For the forgoing reasons, Busse Broadcasting Corporation respectfully requests that the staff reconsider its action and deny the Petition for Rulemaking filed on behalf of Citadel Communications Co., Ltd. to substitute UHF Channel 18 for VHF Channel 8 at Albion, Nebraska and allot VHF Channel 8 at Lincoln, Nebraska.

AFFIDAVIT OF JOHN P. ALLEN

ENGINEERING STATEMENT

The engineering data contained herein have been prepared on behalf of BUSSE BROADCASTING CORPORATION, licensee of KOLN(TV), Lincoln, Nebraska, in support of its Petition for Reconsideration in MM Docket No. 91-304

FIGURE 1
PREDICTED GRADE B CONTOUR OVERLAP

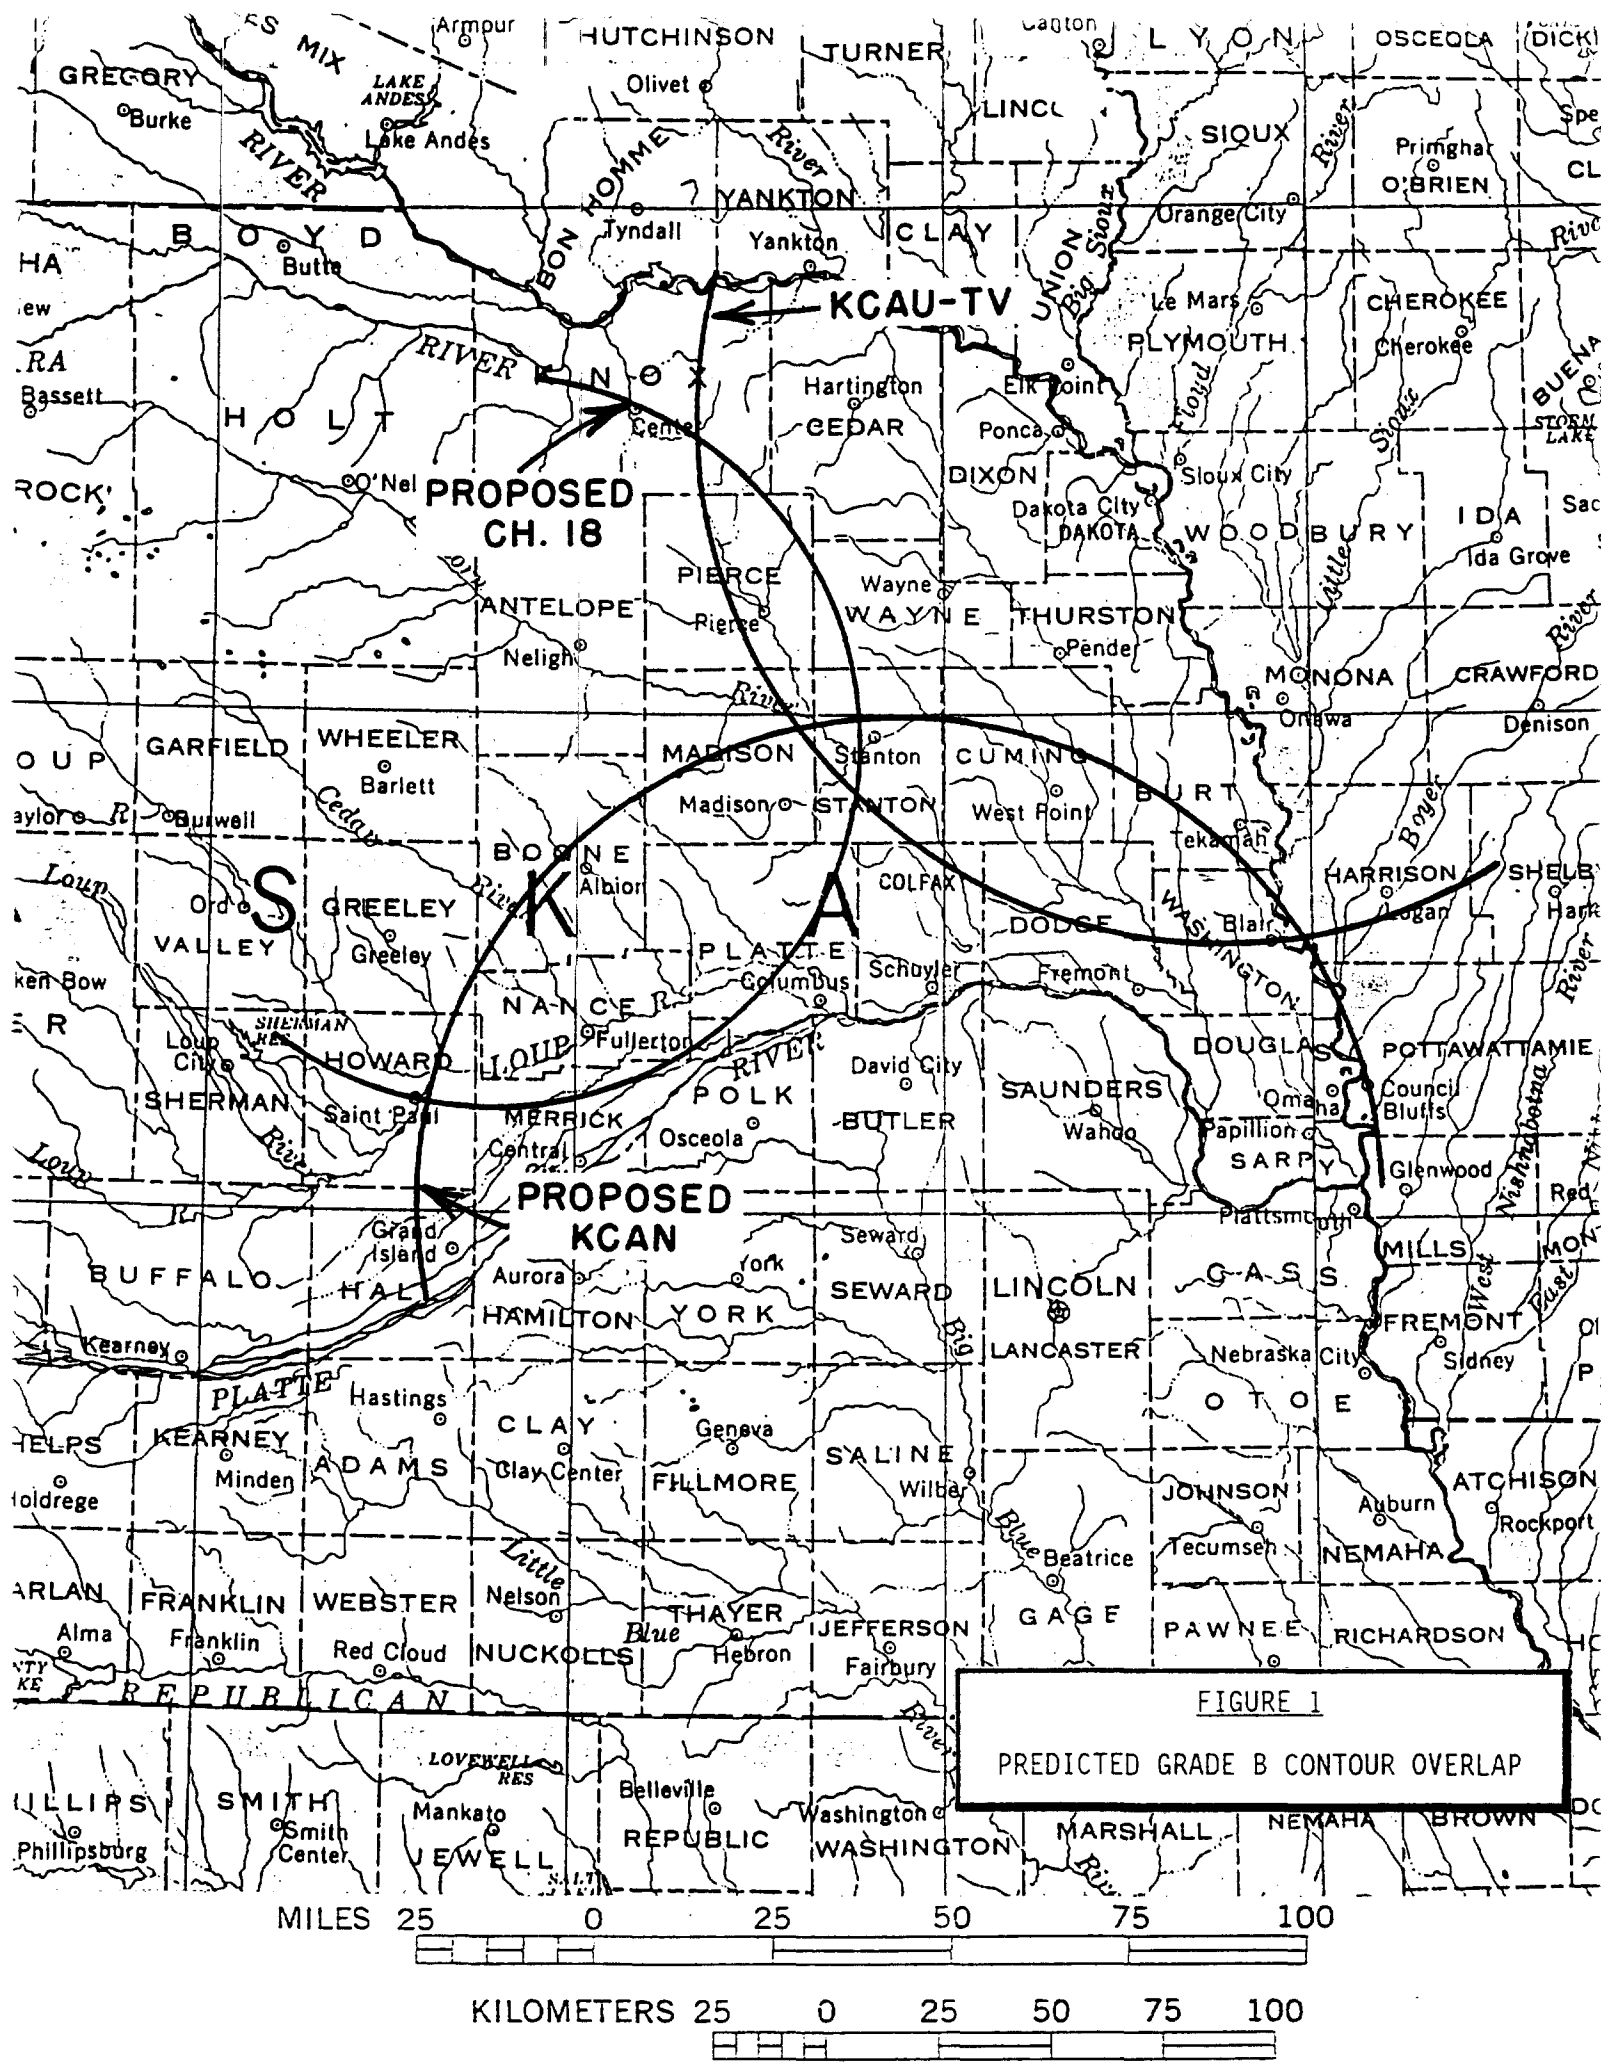
With respect to the contour overlap that would result, we attach Figure 1, which shows portions of the Grade B contours of KCAU-TV; the

proposed KCAN, Lincoln, facility; and the proposed Channel 18, Albion, facility. The Channel 18 contour is based on a facility of 2500 kw at 1200 feet, as proposed by Citadel, at the geographic coordinates proposed by Citadel. The KCAN facility is as proposed by Citadel but at the geographic coordinates specified by the Commission in its *Report and Order*.

FIGURE 3
 PREDICTED GRADE B SERVICE CONTOURS
 AND WHITE AND GRAY AREAS
 CHANNEL 18, ALBION, WITH 2500 KW AT 1200 FEET

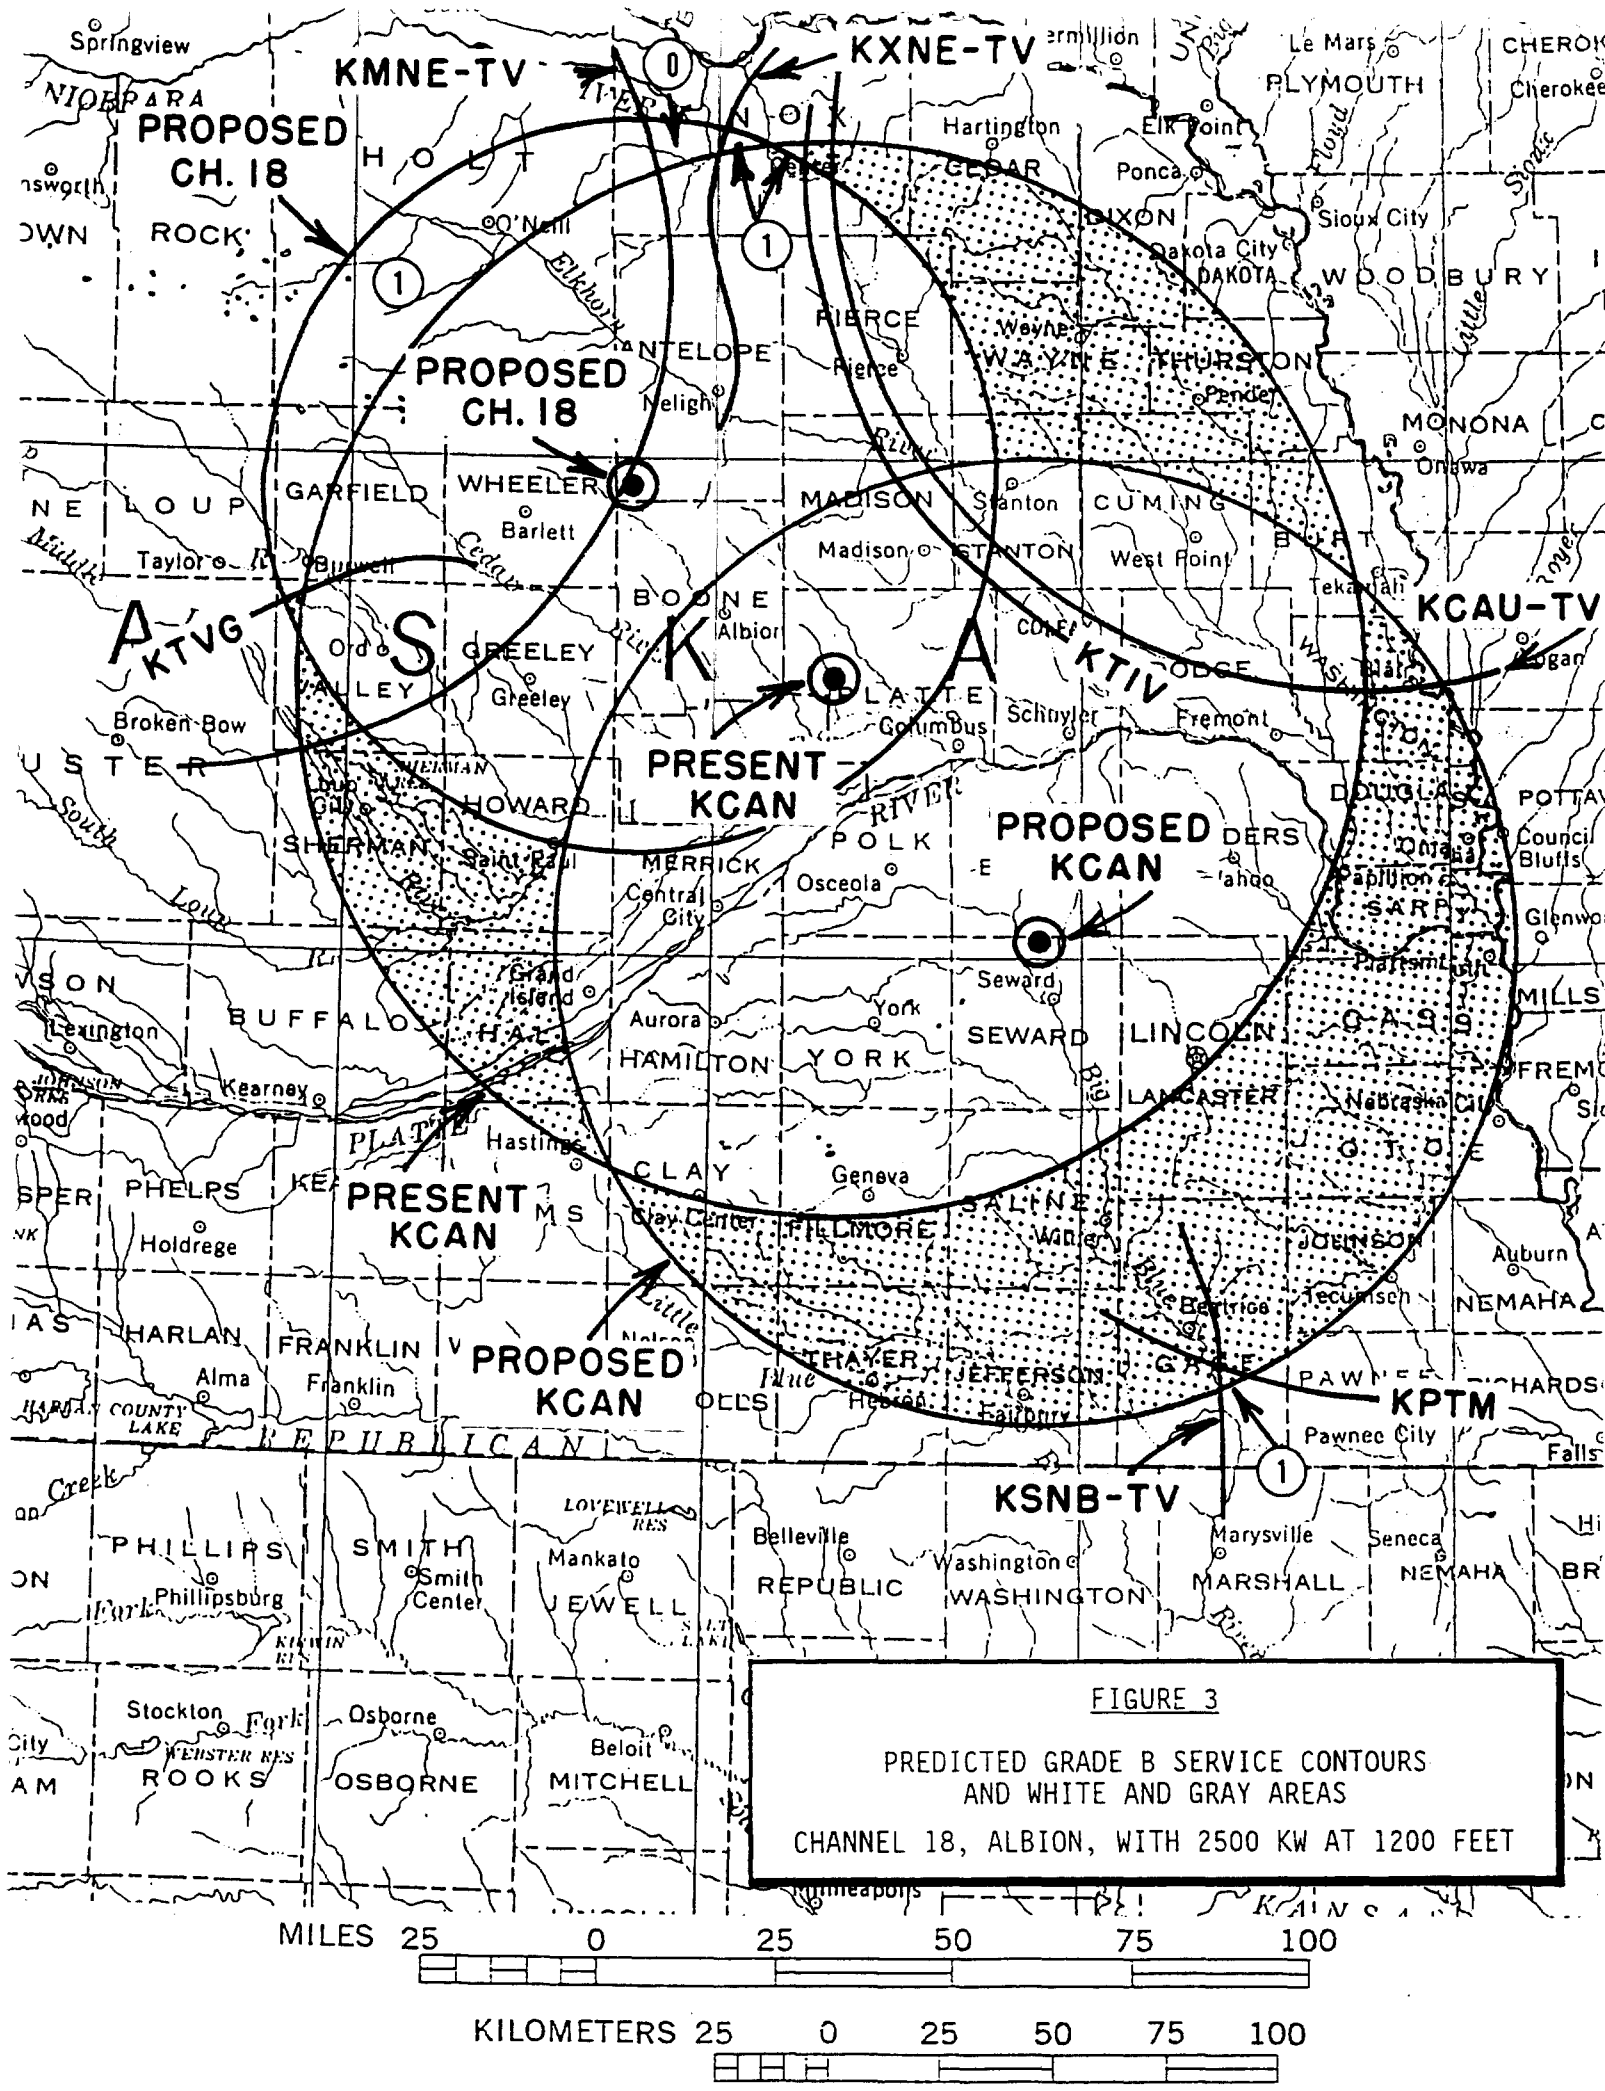
Figure 3 addresses the question of gains and losses. It shows the Grade B contours of the present KCAN operation, the proposed KCAN operation, and the proposed Channel 18, Albion, operation, with a portion of the KCAU-TV Grade B contour for reference. In addition, we have shown the areas in question that would gain or lose a first or second Grade B service under this proposal. While a number of other Grade B contours enter parts of the gain and loss areas, we have shown only those that define the areas with zero or one other service. Pertinent population and area data is tabulated in Figure 4.

The Commission said in its *Report and Order* that the Citadel proposal, as modified in its decision, would provide a first service to 12,433 persons in 1742 square kilometers and a second service to

14,641 persons in 4059 square kilometers. Based on the record, KOLN cannot find any support for figures so large. However, it appears unnecessary to reach agreement on this set of numbers, because it appears to be based on obsolete Commission standards. During the pendency of this proceeding, the Commission has determined that showings of other television services must now include other noncommercial services. As shown in Figures 3 and 4, the correct figures for a first service are 585 persons in 137 square kilometers, and 6985 persons in 2833 square kilometers for a second service.

Although these figures are dramatically lower than those used by the Commission, they are still inflated, because they do not consider other programming sources, such as cable systems or translators. Our study established that the only identifiable community that would receive a first television service is Virdigre, Nebraska, and that the new first service would include approximately 70 percent of Virdigre, population 607. However, Virdigre is served by a cable system and by four translators carrying ABC, CBS, NBC, and PBS programming. Thus, one may properly exclude Virdigre from this gain area, meaning that the effectuation of this proposal would provide a new first television service to 160 persons, clearly a negligible figure in this context.

FIGURE 5
 PREDICTED GRADE B SERVICE CONTOURS
 AND WHITE AND GRAY AREAS
 CHANNEL 18, ALBION, WITH 200 KW AT 1200 FEET

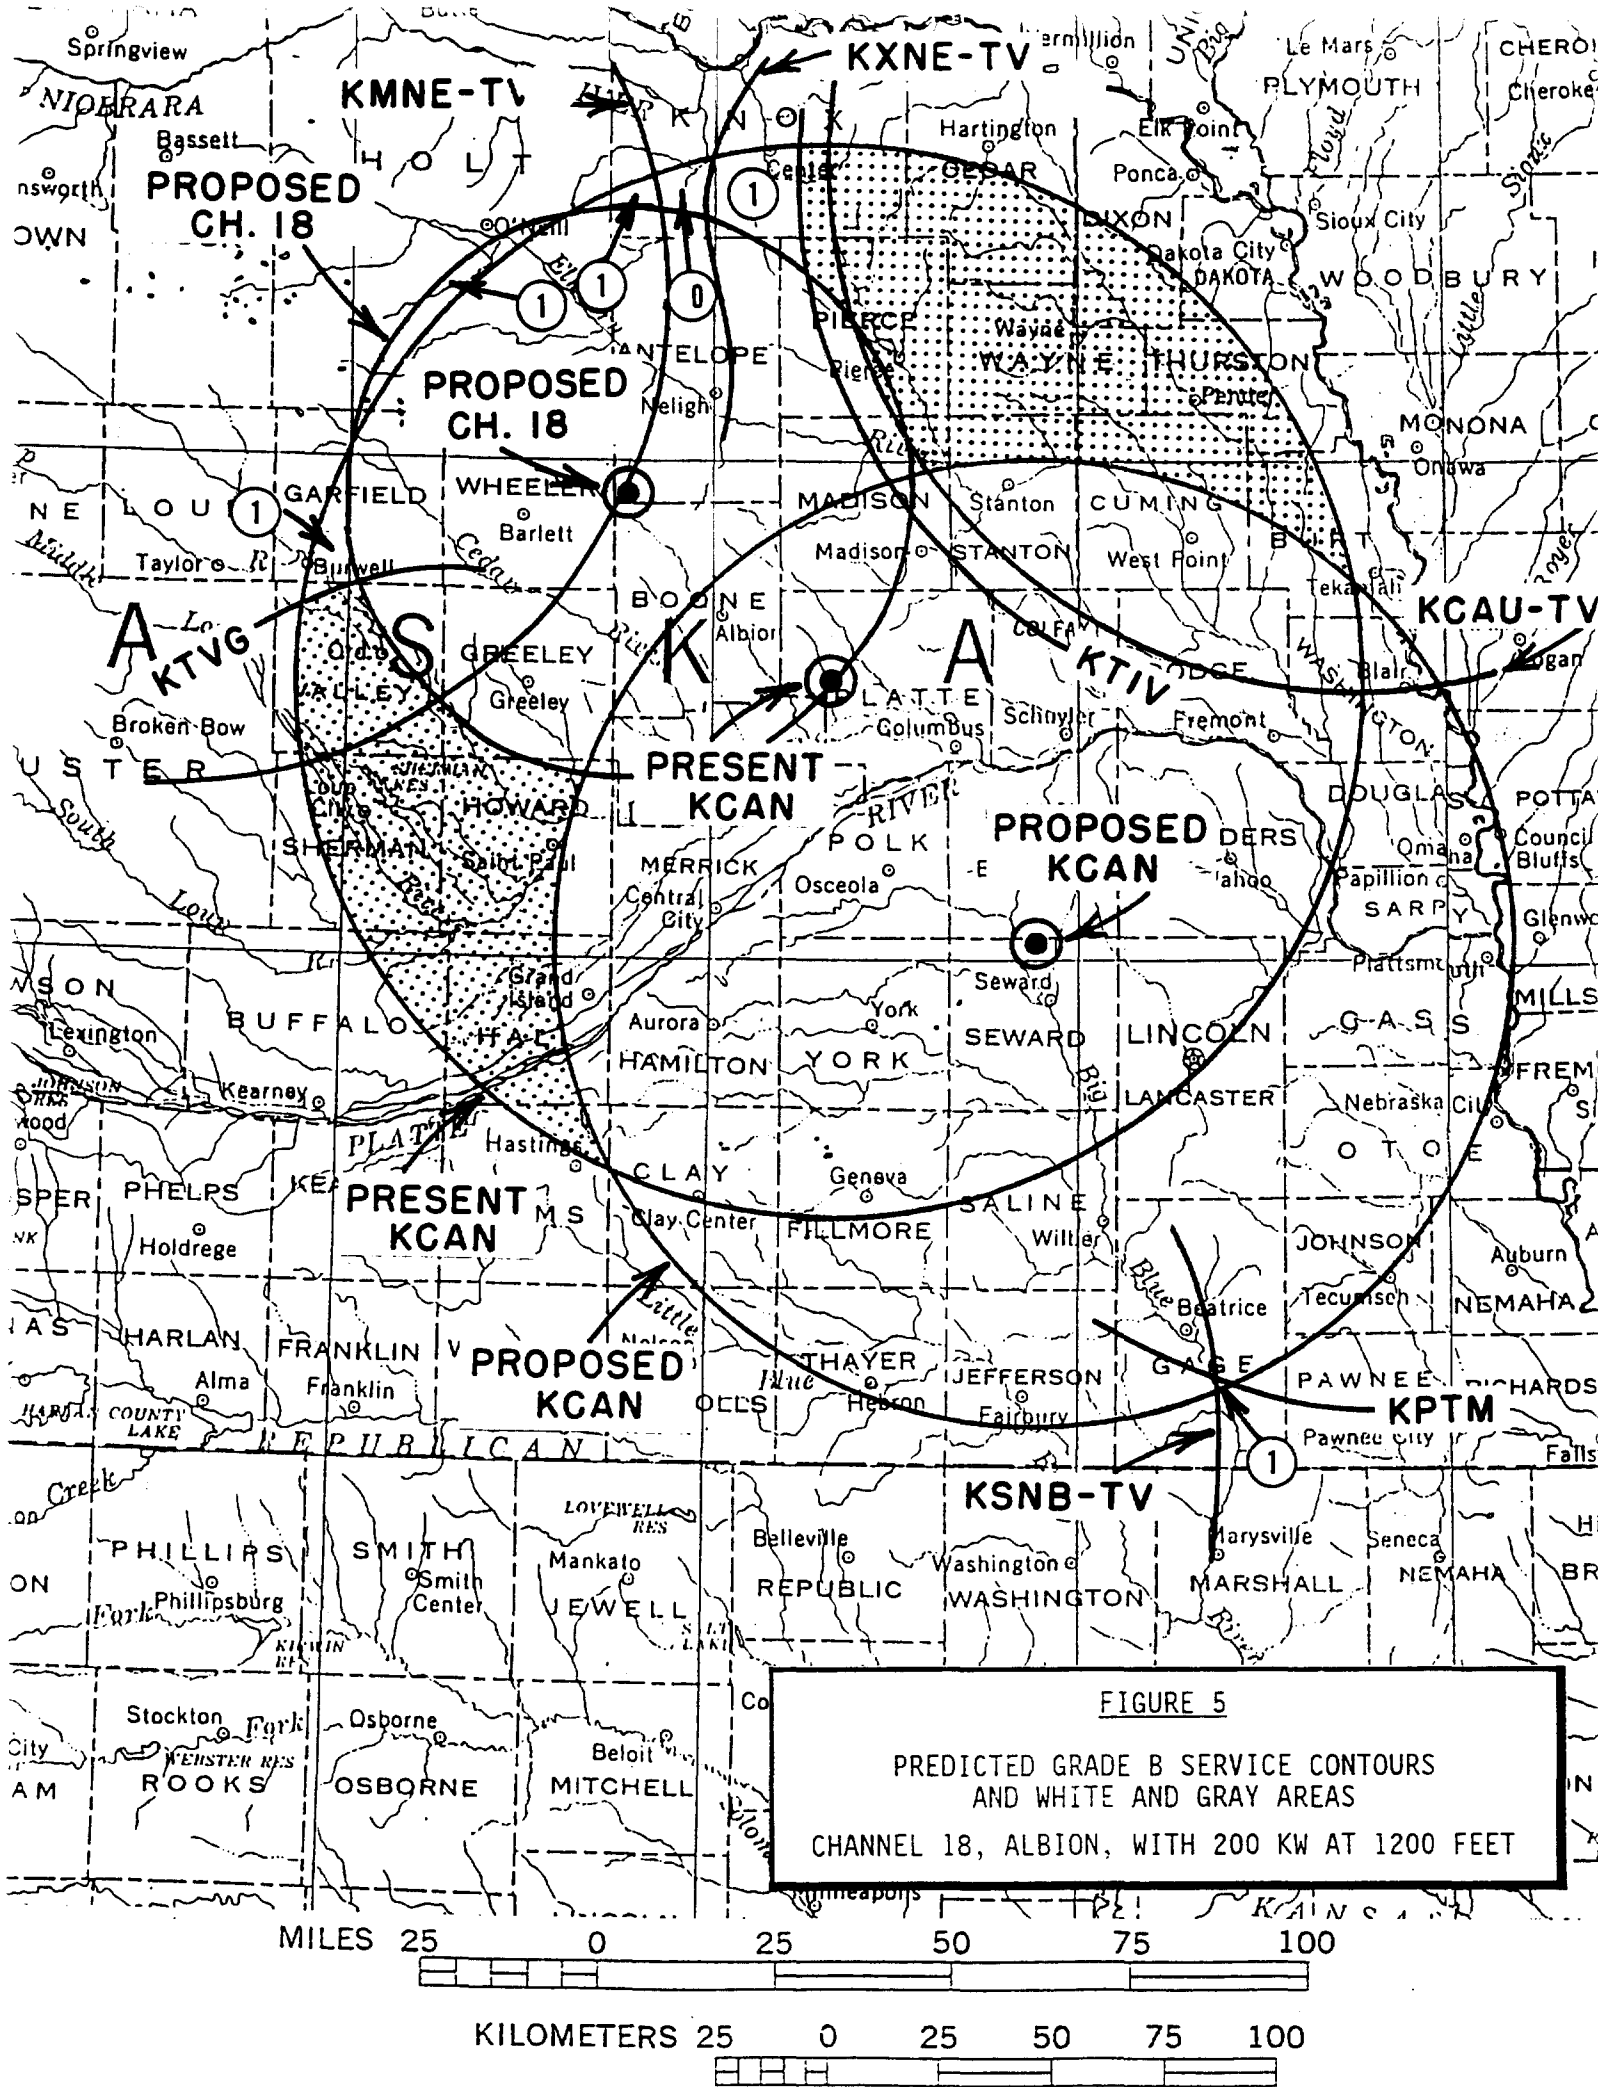
In Figure 5 we show the same Grade B contours as in Figure 3, but with the Channel 18 contour being that which would result from operation with 200 kw at 1200 feet. Population and area data is included in Figure 6. As shown, instead of a net gain in service to white and gray areas, there would be a net loss in service to such areas. Instead of 585 persons receiving a first service, 315 persons would lose their only service.

Similarly, instead of 6985 persons receiving a second service, 2290 persons would be reduced to a single service.
